April 2, 2024

Version 8

RDX Front and/or Rear Brakes Squeal when Applied at Low Speeds

Supersedes 19-053, dated February 28, 2024 to update the information highlighted in **yellow**.

Front Brake Pad Shims Replacement

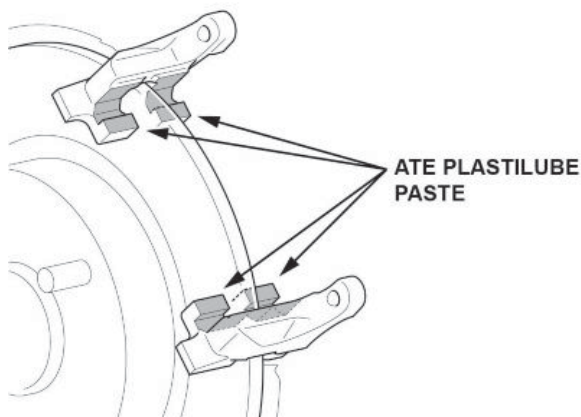
1. Replace **ONLY** the front brake pad shims. Refer to the service information.

NOTE: Make sure to apply the M-77 assembly paste included with the **front brake pad shim kit**.
